ADDENDUM

Project Name: Health Life Safety Work: Exterior Improvements at: Quincy Junior High School

Addendum Number: 1

Issued: 04/11/2019

A203

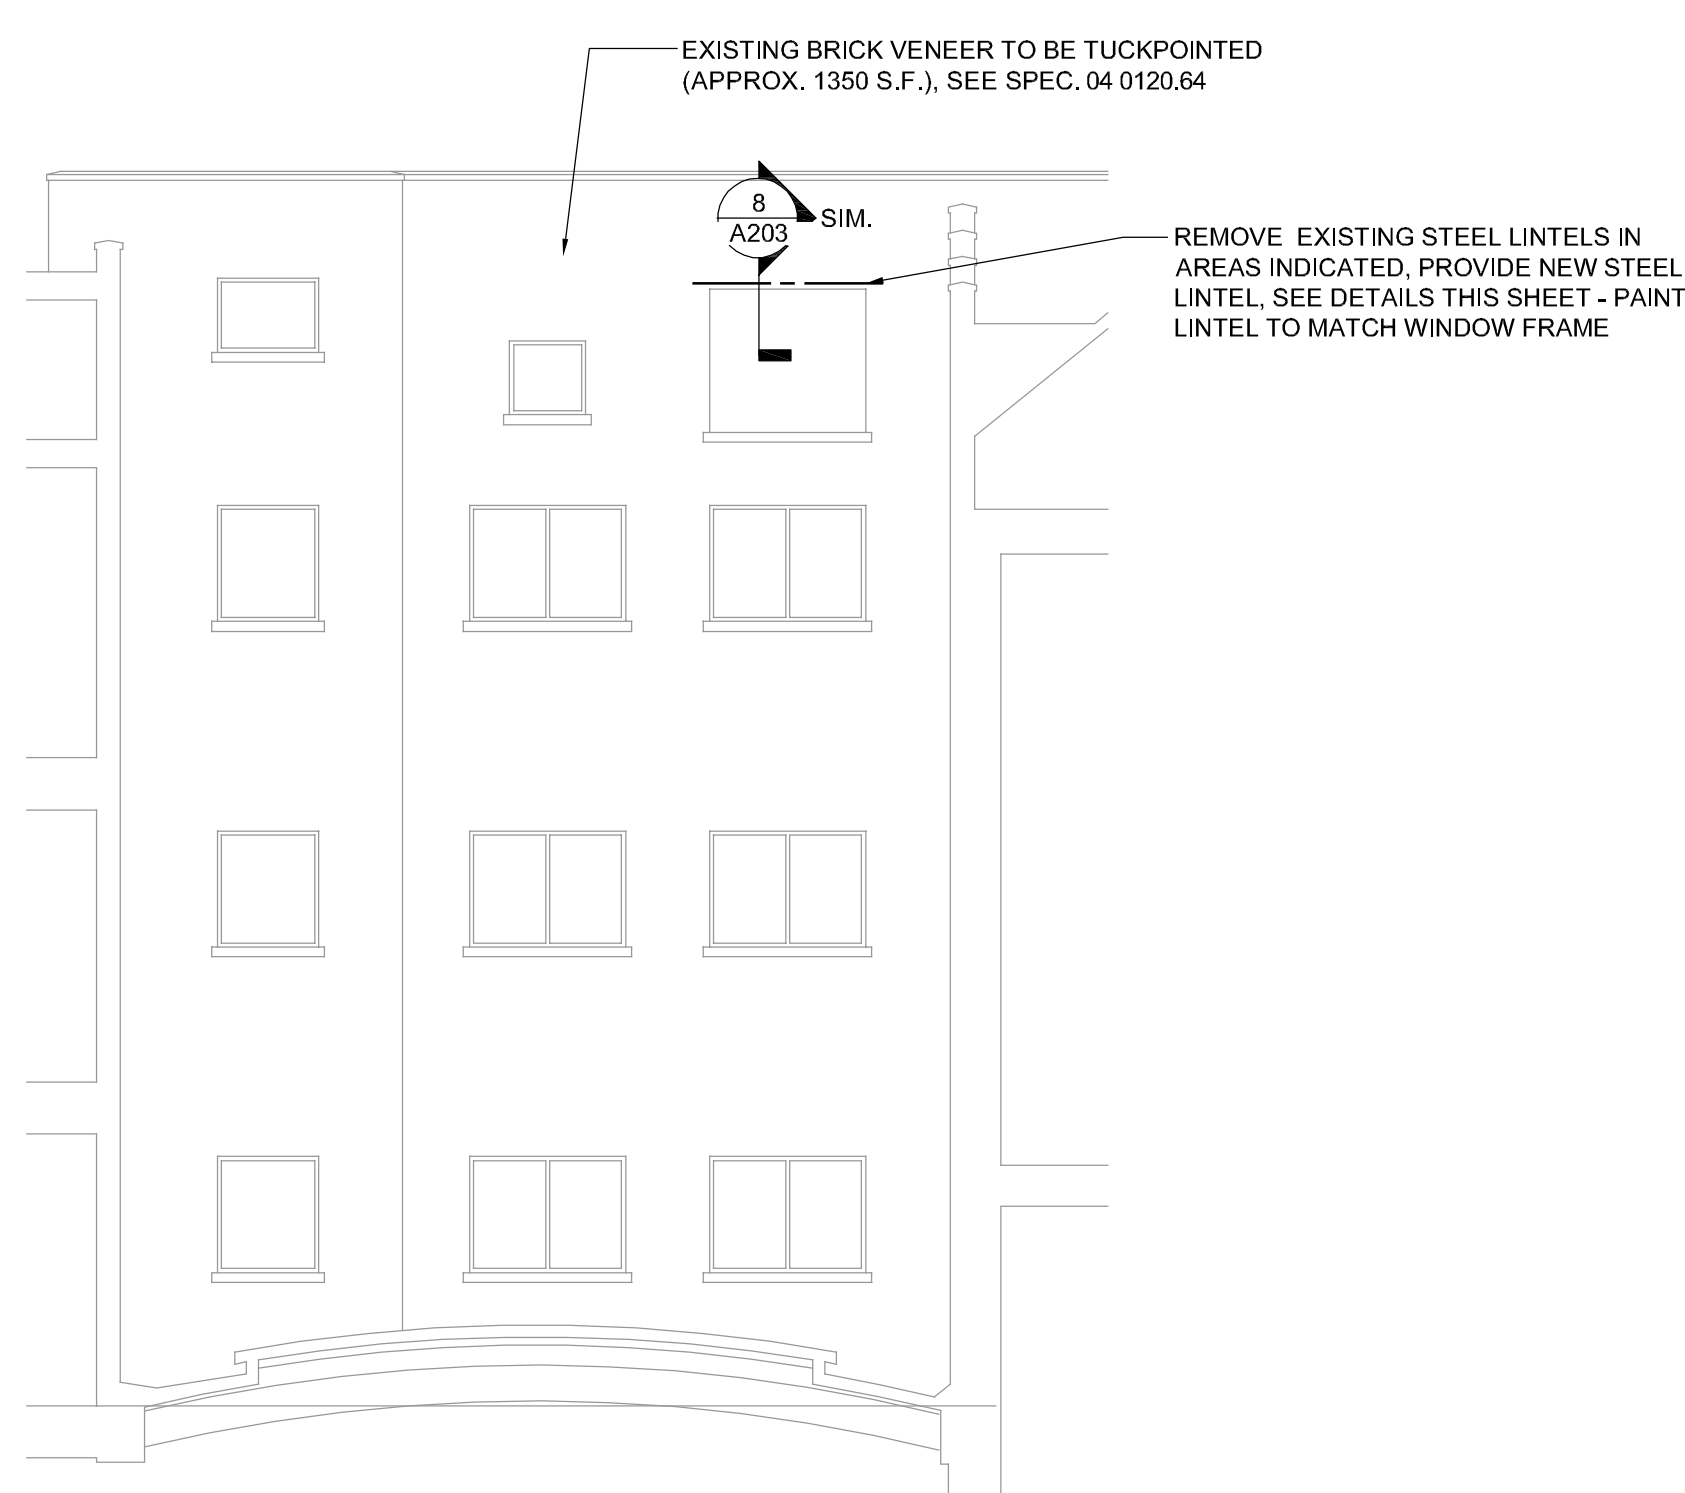
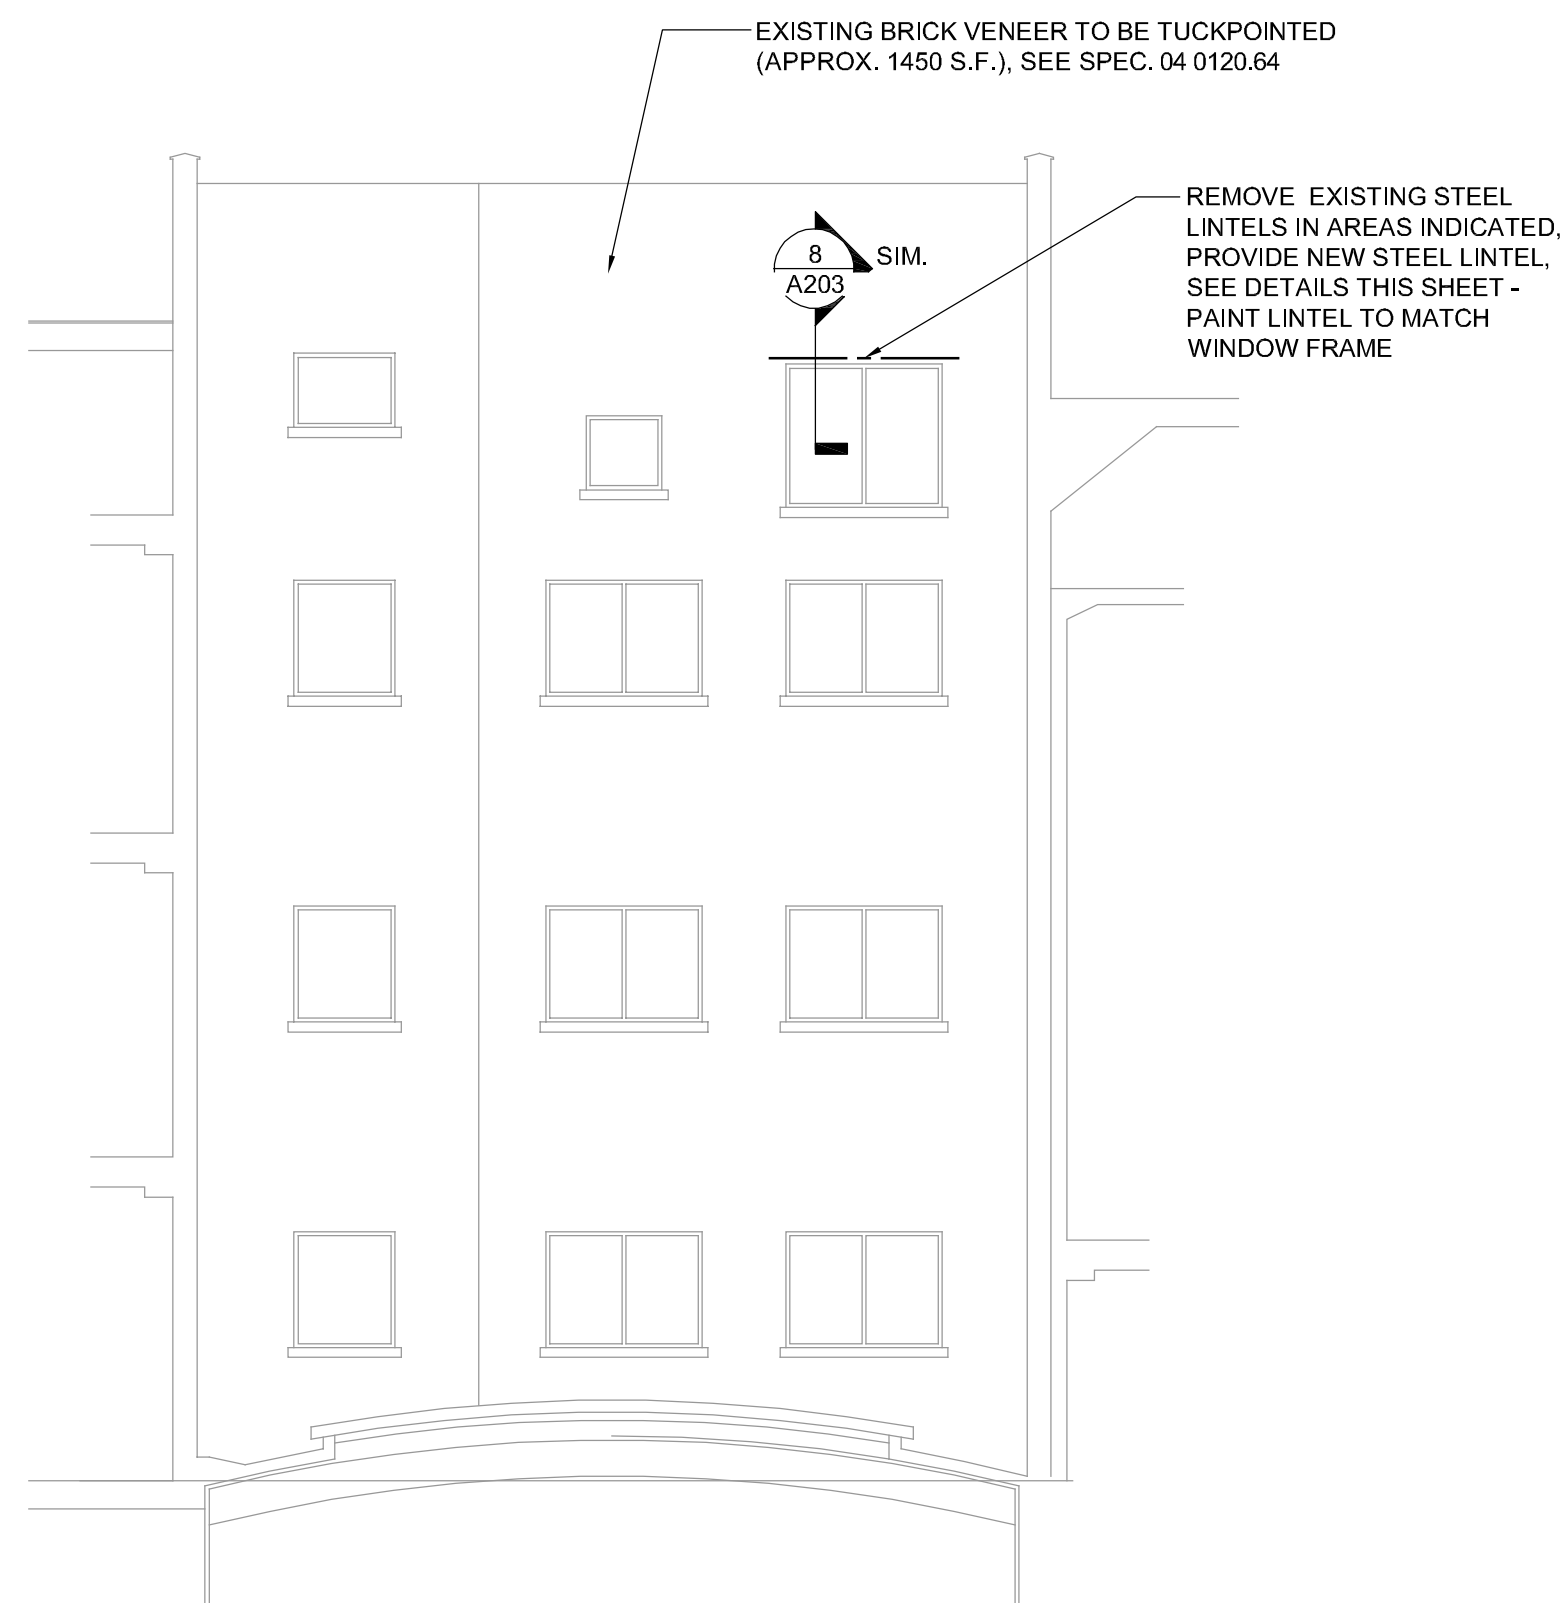
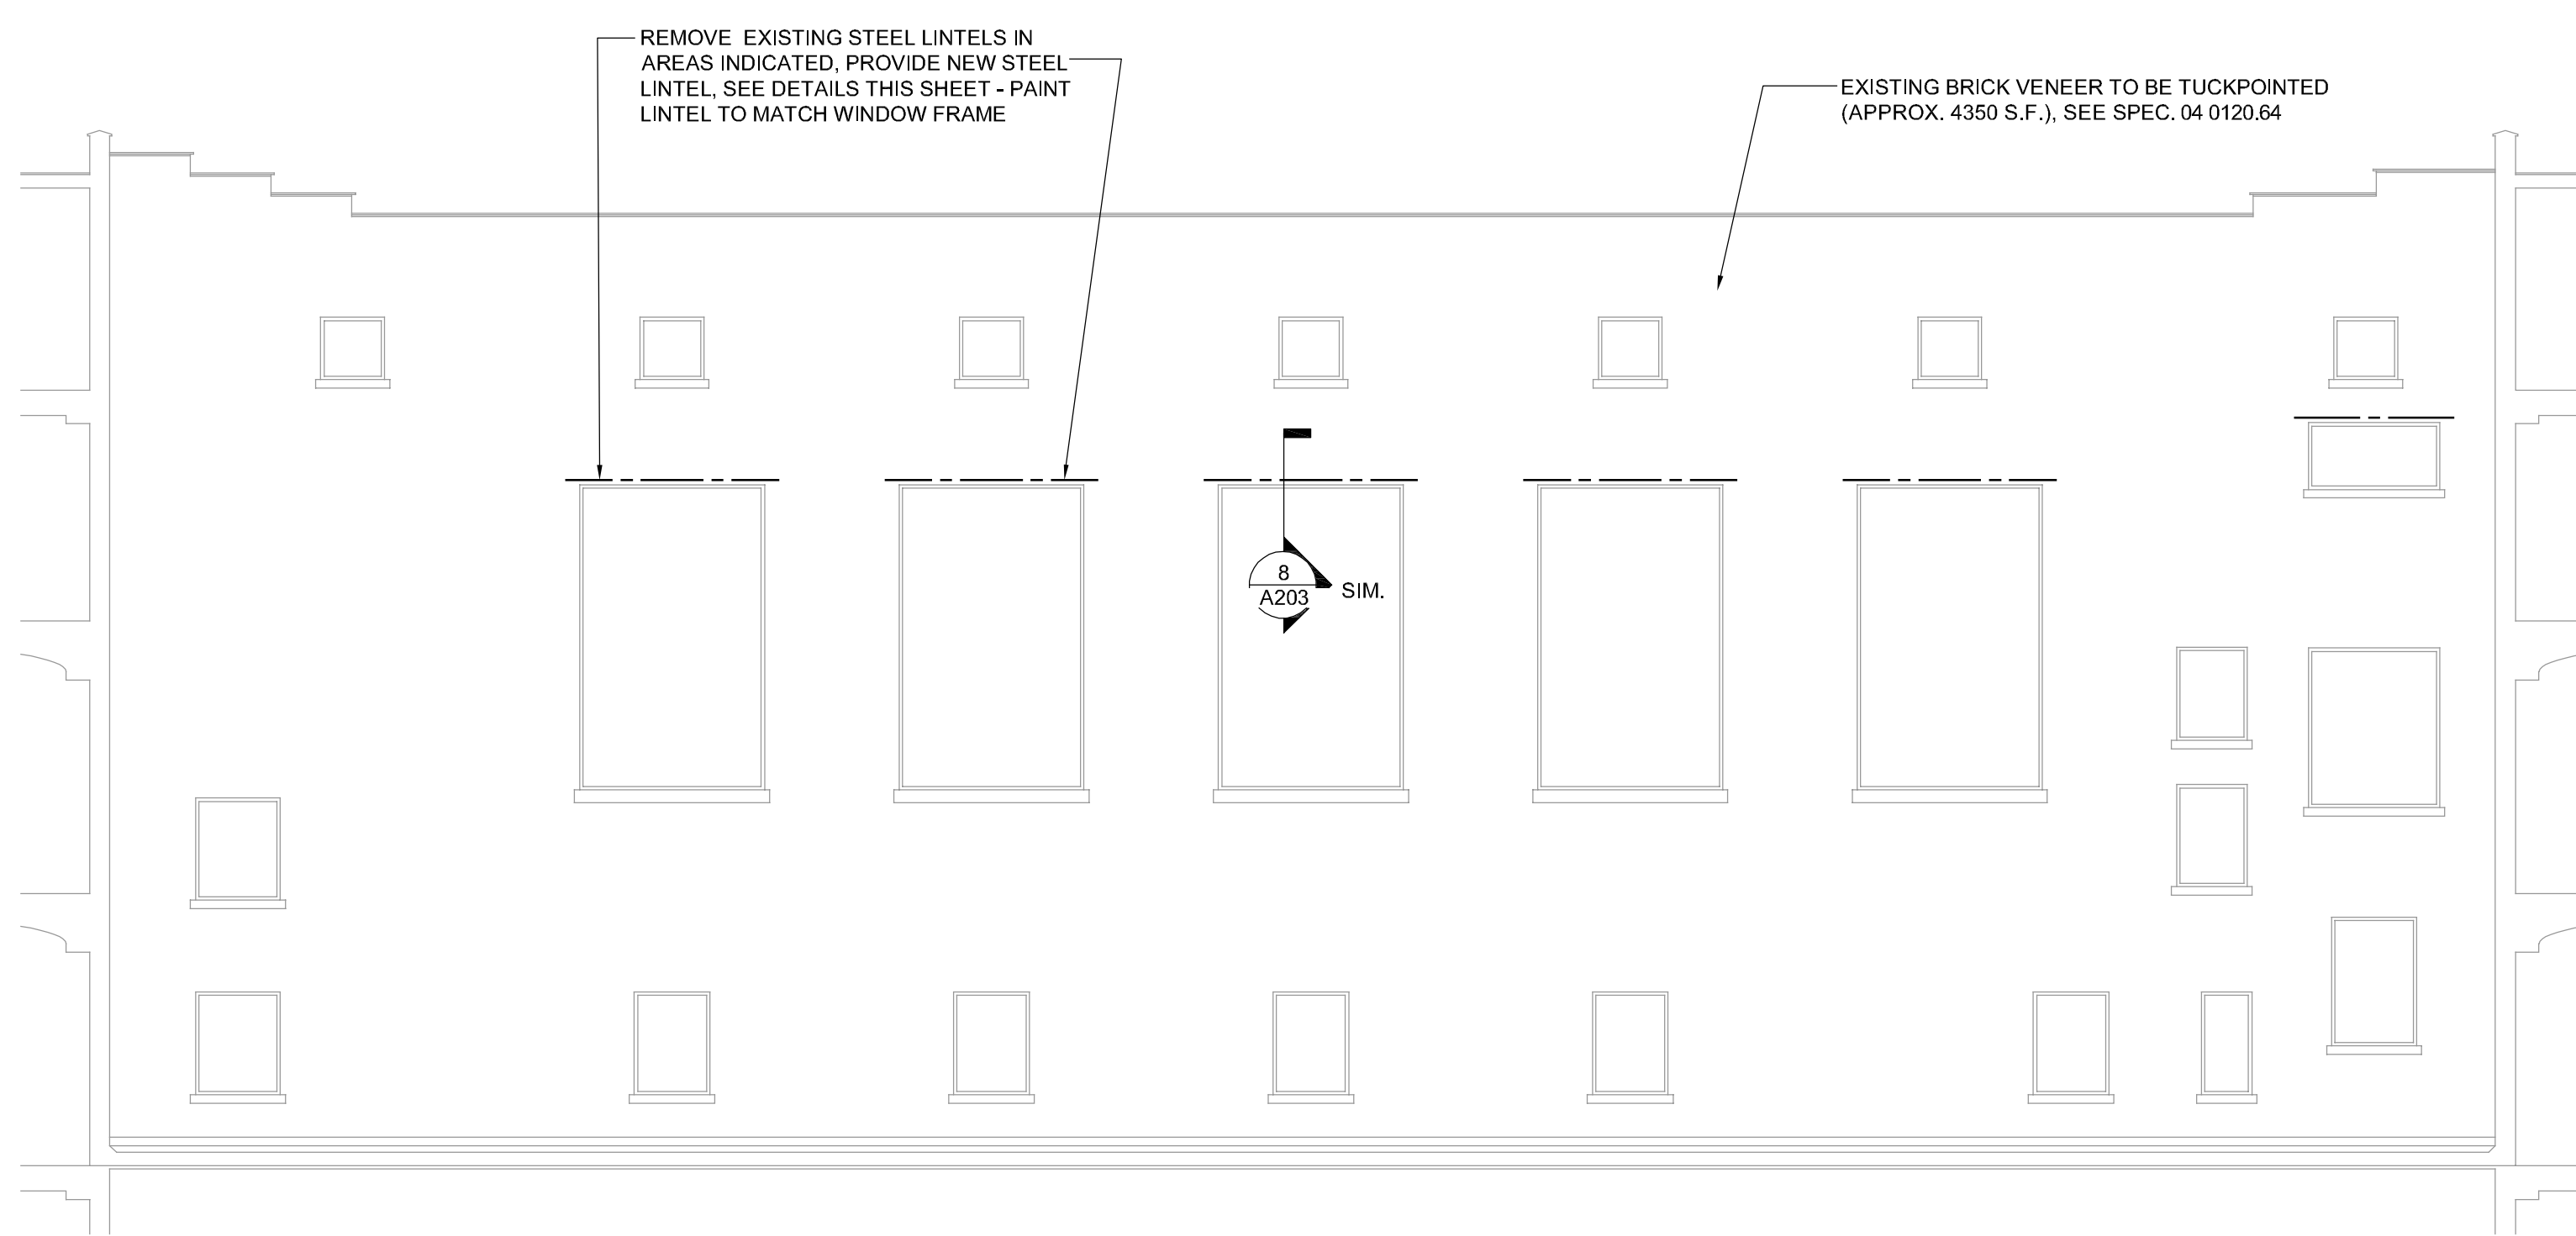
Section 01 5000 Part 3.4	Add	Section "I" - Provide temporary barriers as required to protect existing exterior doors.
Section 01 7000 Part 3.2	Add	Add paragraph "C" - Repair all damaged lawn and landscape areas to original condition.
Section 04 0140.61	Add	The "Matrix" repair system by Conproco is an acceptable product for stone repair.
DRAWINGS:		
A203	Revise	Lintel detail marks have been updated, see attached drawings.
